2 PROJECT DESCRIPTION

2.1 INTRODUCTION

This section of the IS/MND describes the Proposed Project, including the existing electrical system, project components that would be installed or modified, construction activities and methods, and operation and maintenance activities. The project overview, location, and objectives are provided in Section 1: Introduction. SDG&E proposed measures to reduce environmental impacts and an overview of electromagnetic fields (EMF) associated with the Proposed Project are provided at the end of this section.

Figure 2.4-1 Diagram of Proposed 69-kV Duct Bank

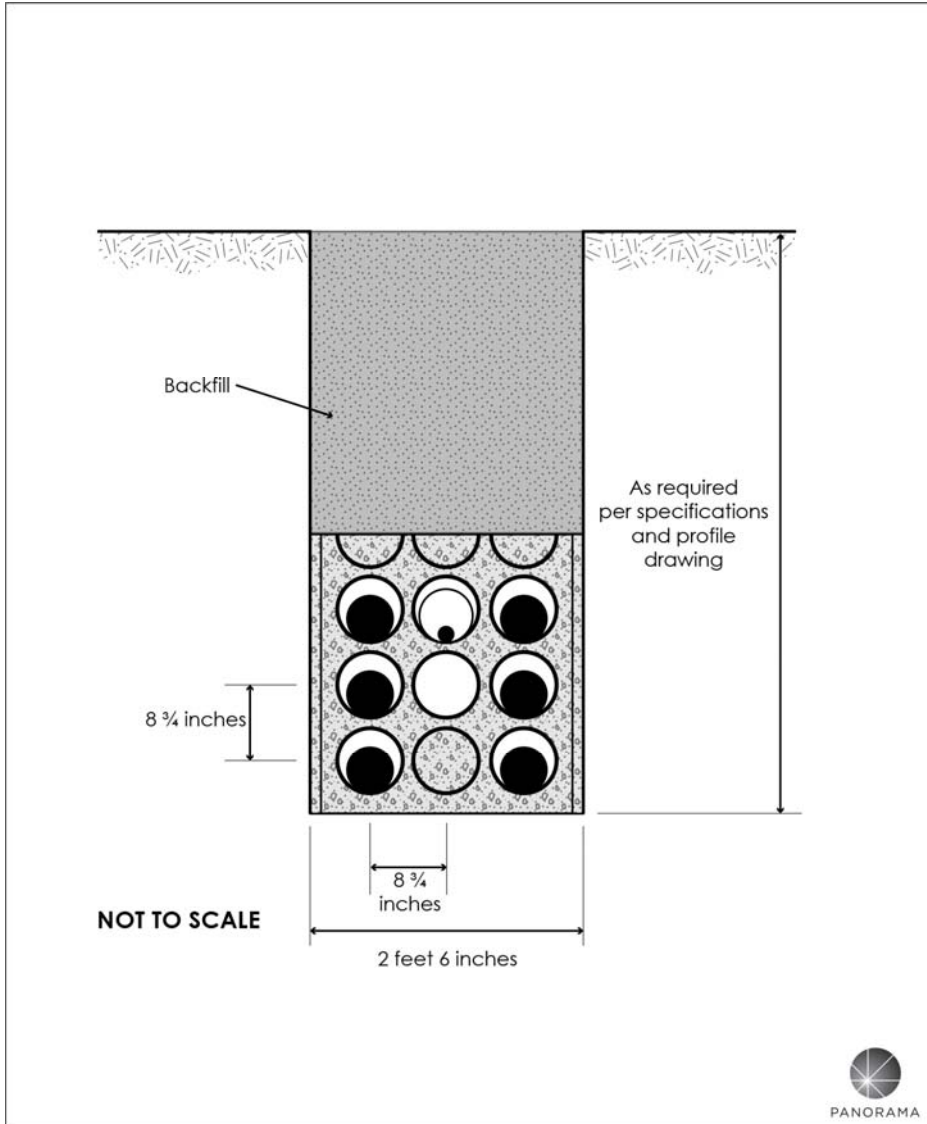
Commented [w14]: SDG&E: provide a diagram of a single-circuit 69-kV underground duct bank
See also Data Request Item 14.
